## Response to Submissions

Prepared for Tahmoor Coal Pty Ltd

February 2020

Job No.: 60588857

FIGURE 2.1

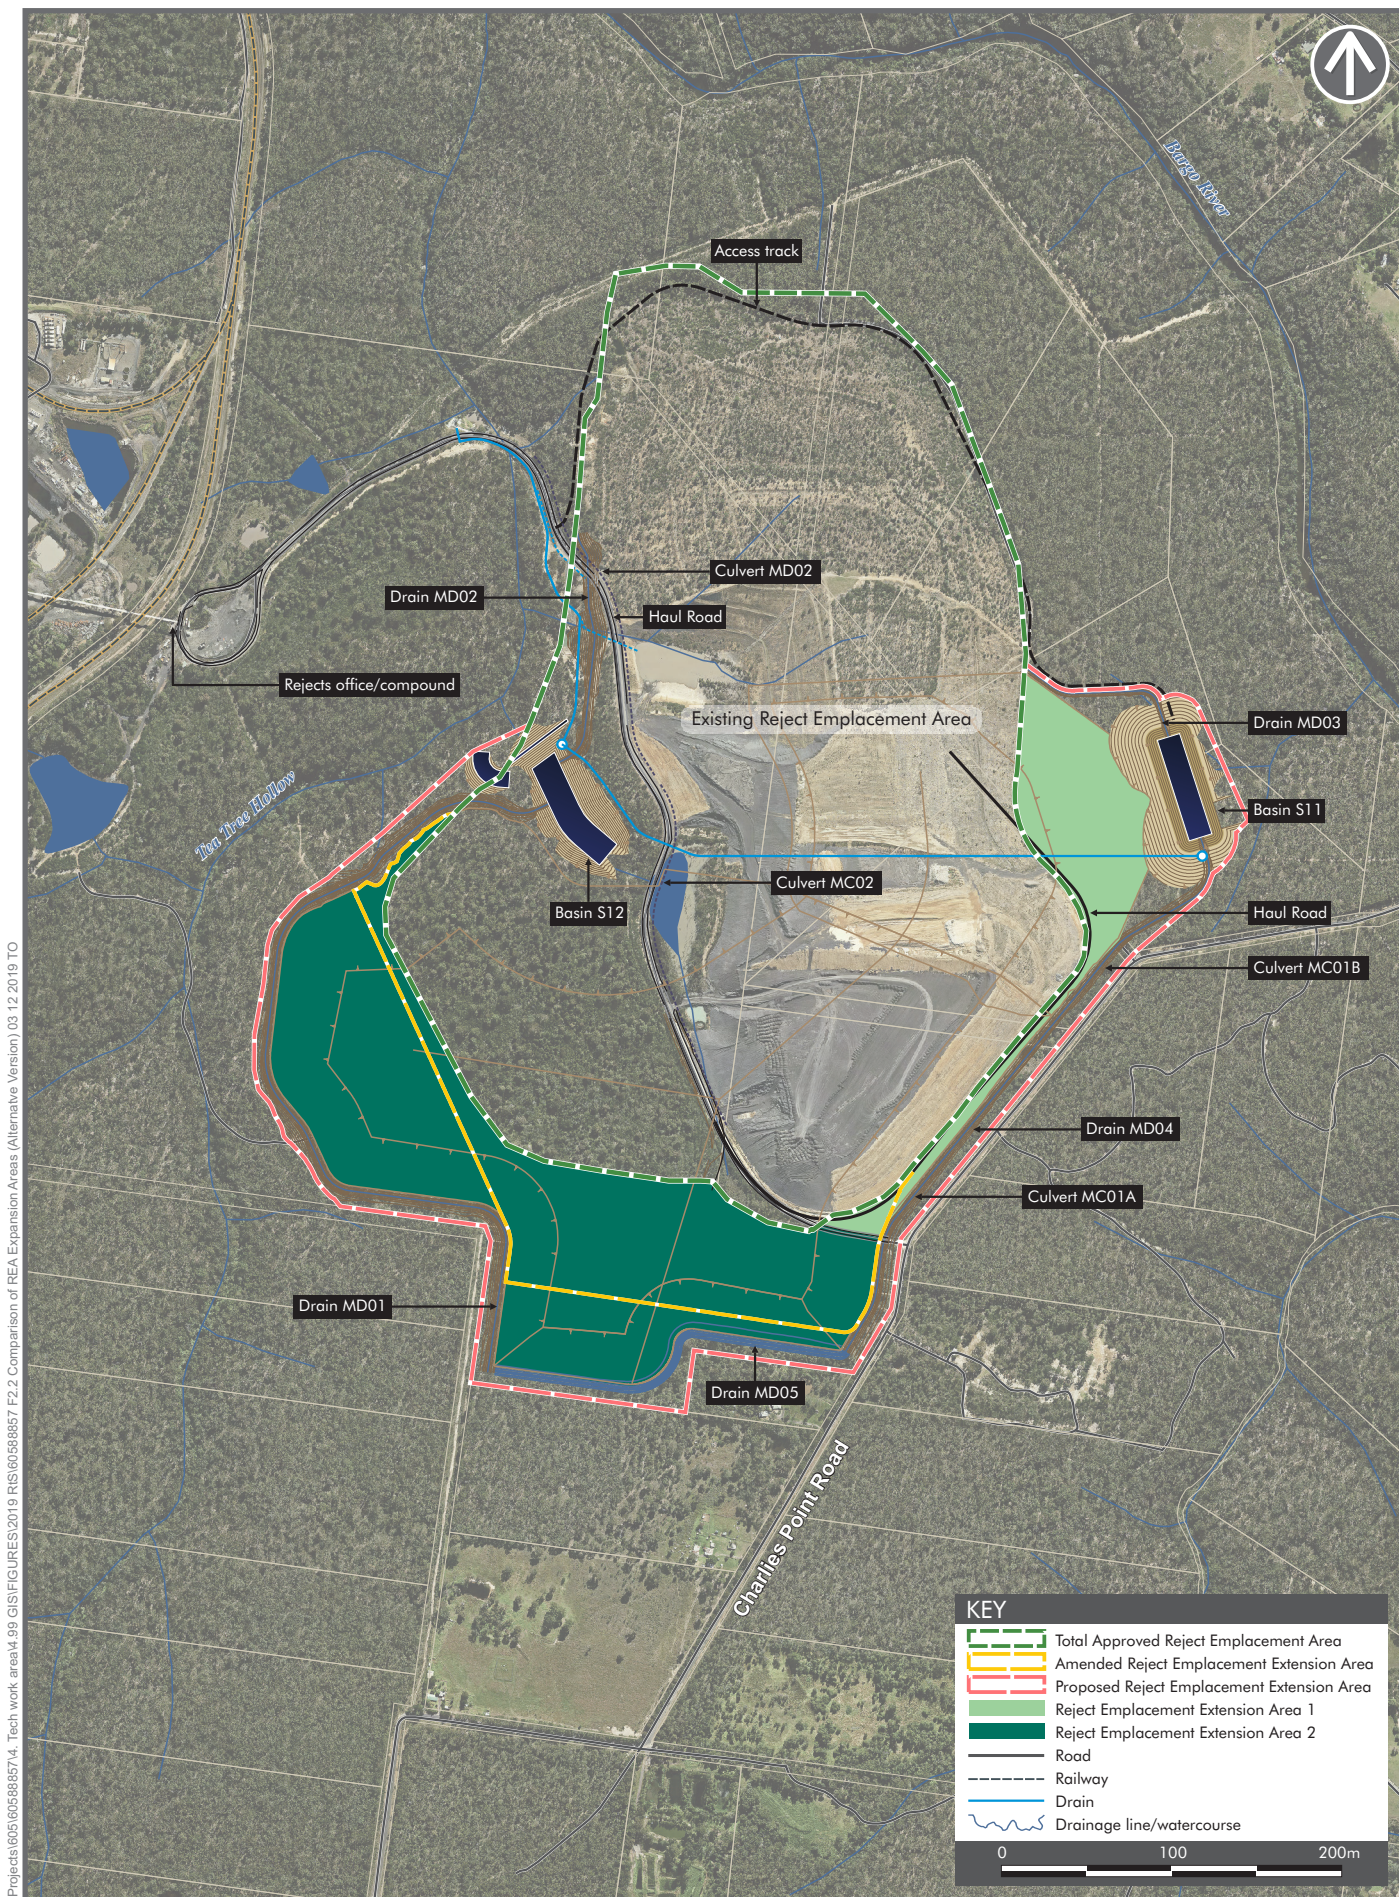
Key issues raised in submissions included concerns relating to the proposed extent of longwall mining, the associated subsidence impacts, greenhouse gas emissions and the extent of vegetation clearing required for the extension of the REA. In response to these and other issues raised in submissions, and as a result of ongoing mine planning, several amendments have been made to further reduce the predicted environmental impacts of the Project. Key amendments to the Project are include:

- Amended mine plan including:
  - Removal of LW109, which was directly beneath Dog Trap Creek;
  - Reconfiguration of the longwall layout to comprise two series of shorter longwall panels;

- Removal of LW109, which was directly beneath Dog Trap Creek;
- Reconfiguration of the longwall layout to comprise two series of shorter longwall panels (refer **Figure 2-1**);
- Reduction in the proposed longwall width, from approximately 305 m to approximately 285 m; and
- Reduction in the height of extraction within longwall panels from up to 2.85 m to up to 2.6 m.

Figure 5-1 Transient Sensitivities – Groundwater Model

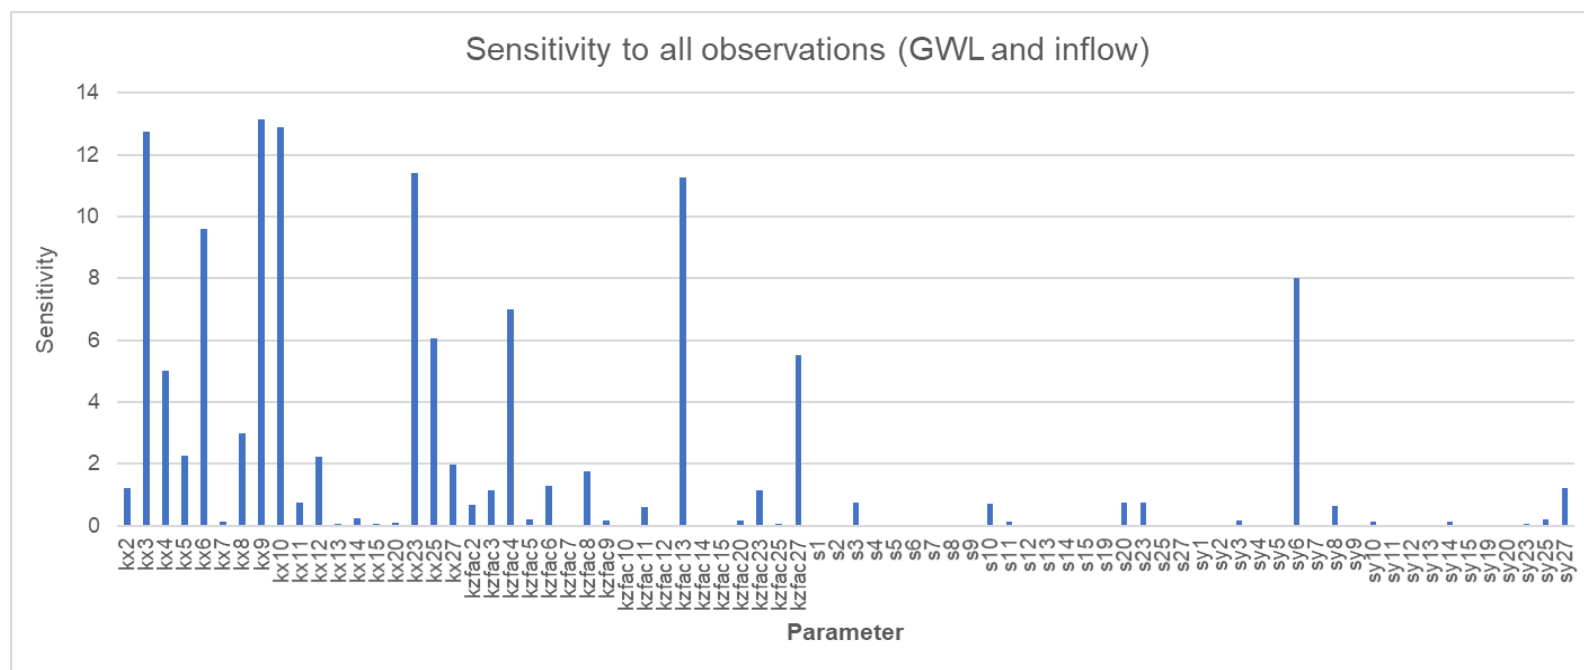
cc	Justification of the adopted bed conductance (C) values (e.g. 100 m <sup>2</sup> /d for drain cells representing longwalls).  Conductance = k.x.y/t. Conductance of longwall Drains is difficult, and there is no clear calculation of what the t (thickness term) should be, i.e. vertical thickness or horizontal distance. In fact, it should be a combination of both. We applied k = 0.01 m/d for 100 x 100 m cells, and a thickness of 1 unit. This conductance has achieved desaturation of the mine workings, and the mine inflow is well calibrated.
dd	As the effects on baseflow may be underestimated, especially in low flow conditions, transient analysis should be undertaken to identify the magnitude of depletion and possible length of dry periods.  Regional groundwater models are not the tool for estimating change to length of dry periods – that is the role of the SWIA.
ee	Justification for the use of the Modflow River Package rather than the MODFLOW lake package to represent the Thirlmere Lakes and use the most appropriate package based on the analysis.  The RIV package is appropriate for use in the groundwater model. It would be ideal to use the Lake package in a local-scale model. But the groundwater model is already dealing with competing objectives: regional simulation for cumulative effects geomechanical changes trying to accommodate watercourse/lake-scale detail. To add the Lake package would mean that short-term dynamics like runoff, direct rainfall, open water evaporation would all need to be added. Further, the Lake package is notoriously difficult to achieve convergence with. The Surface Water model by HEC accounts for those processes, allowing the regional groundwater model to concentrate on simulating the ~40 years of historical mining and the proposed/future mining at appropriate scales while providing estimates of GW-SW flux to/from the lakes.

Sub issue	Response
ff Provide more detailed information on the natural variability or a base case of ponded water levels in Thirlmere Lakes to justify the statements made within the EIS. A stochastic sensitivity analysis would allow the department to identify the uncertainty in the model used for Thirlmere Lakes.	Detailed modelling of surface water stages (lake levels) is described in the Surface Water Assessment by HEC (Appendix D of Project Amendment Report). However, we note that Tahmoor South is >3.6 km from Thirlmere Lakes.

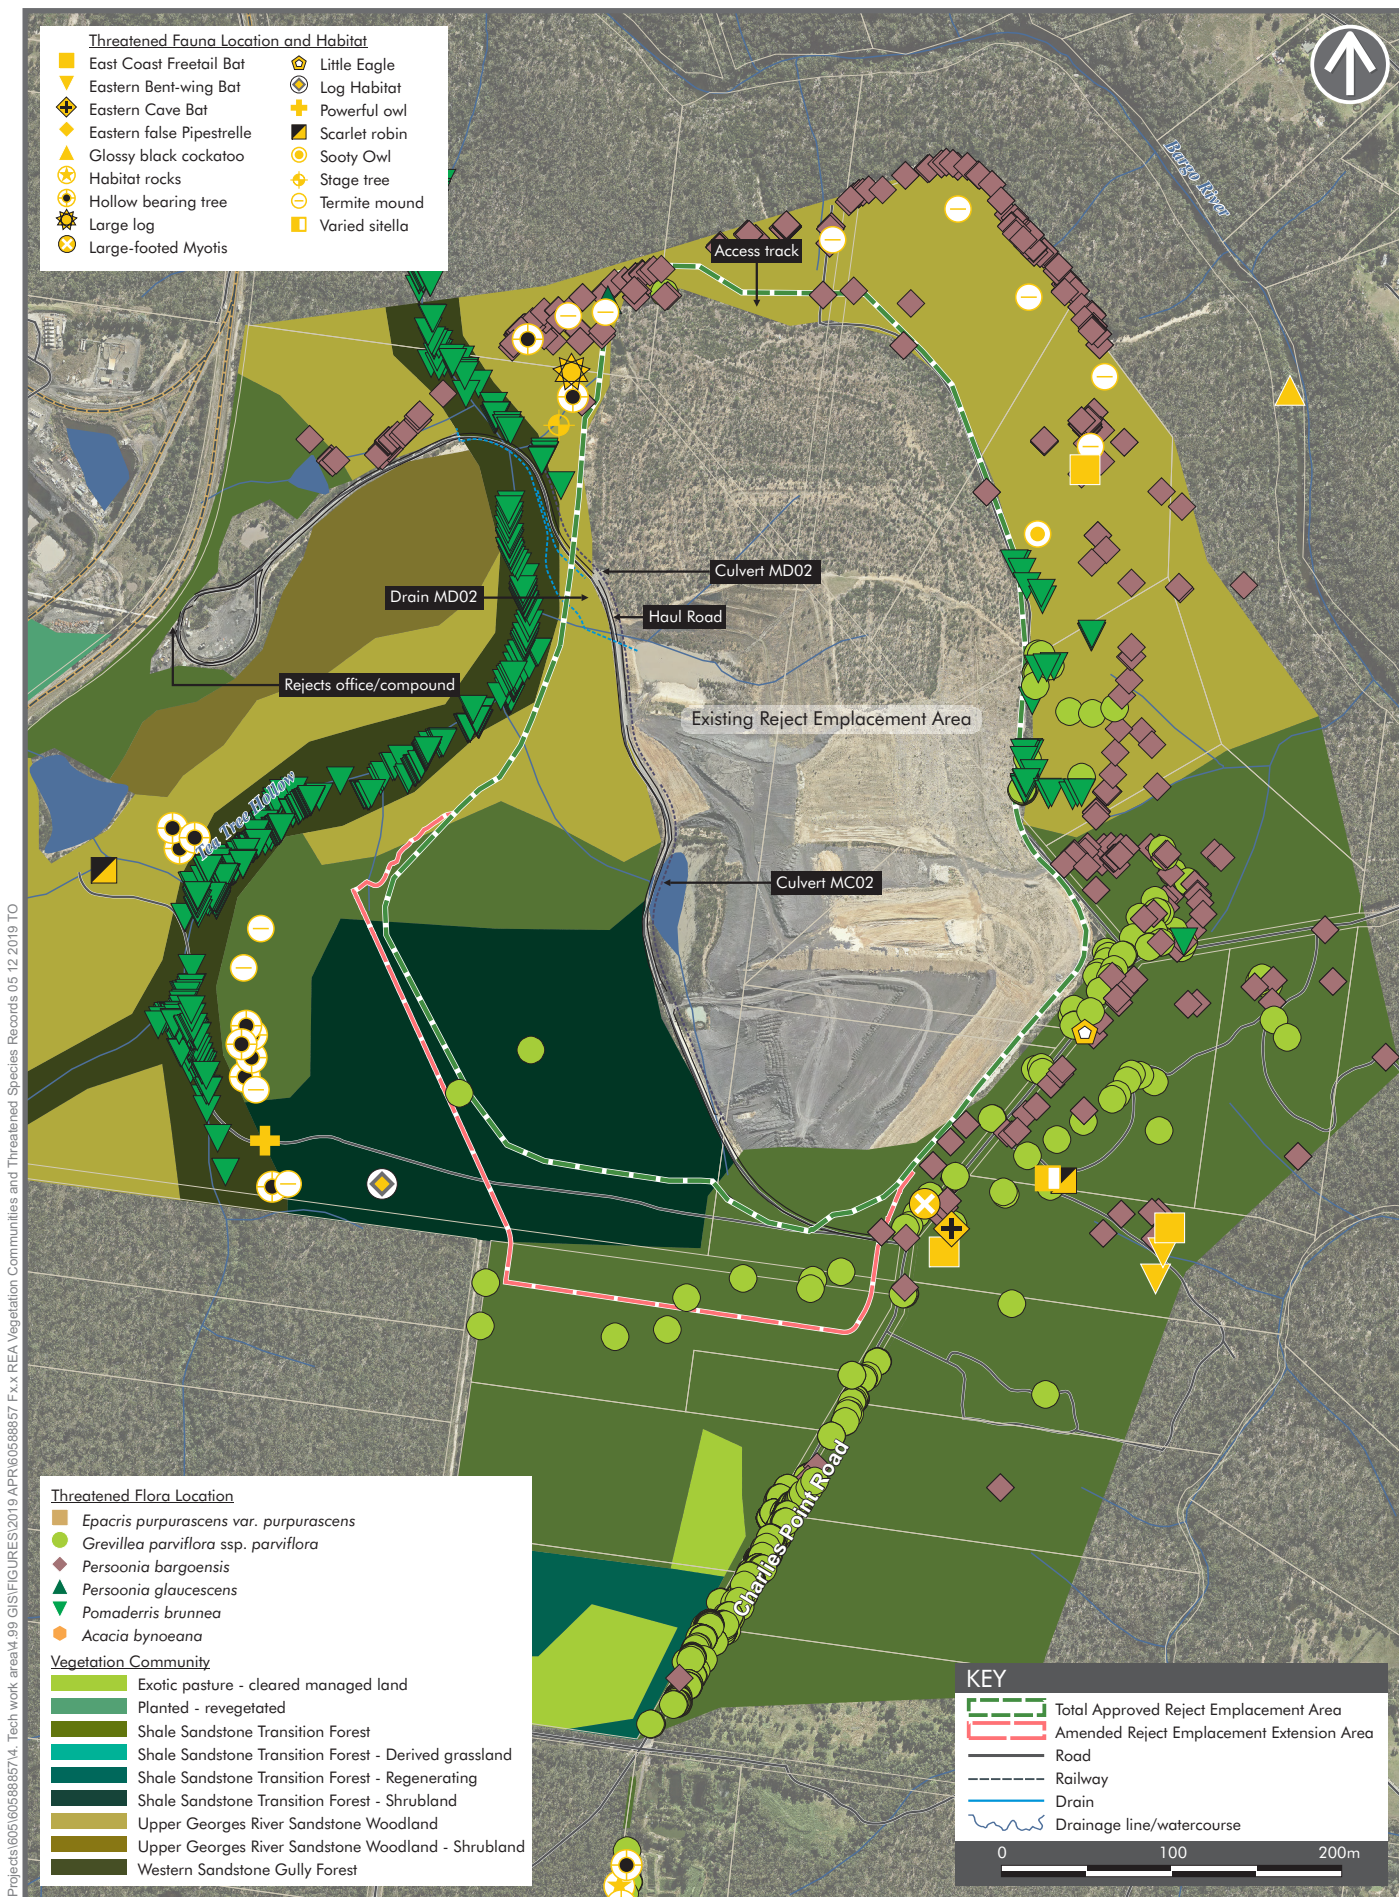
The EIS proposed to extend the existing REA by 43 ha, which would have required the clearing of a total of 39.7 ha of native vegetation, mainly comprising the Shale Sandstone Transition Forest (SSTF) endangered ecological community (34 ha). Government agency and community concerns related to the impacts of the proposed extension to the REA on native vegetation, and whether alternatives to extending the REA had been properly explored. In response to these concerns, Tahmoor Coal has:

- Undertaken further investigations into alternatives to surface emplacement of rejects; and
- Amended the Project to reduce the REA extension footprint from 43 ha to 11.06 ha, resulting in a reduced extension area of approximately 74% (refer **Figure 2-2**).

To account for a quantitative measure of indirect impacts, a 100 m buffer has been placed around the Amended Project Area. This buffer would likely encapsulate the potential spread of weeds, edge effects in surrounding vegetated areas, erosion, dust, intensive light spill, and sedimentation during construction and operation. The overall design of the REA carefully considered balancing the impacts between vegetation removal and amenity. This reduction in vegetation clearance would allow Tahmoor Coal to achieve the required offset liability. **Figure 5-3** shows the EIS REA and the amended REA footprint.
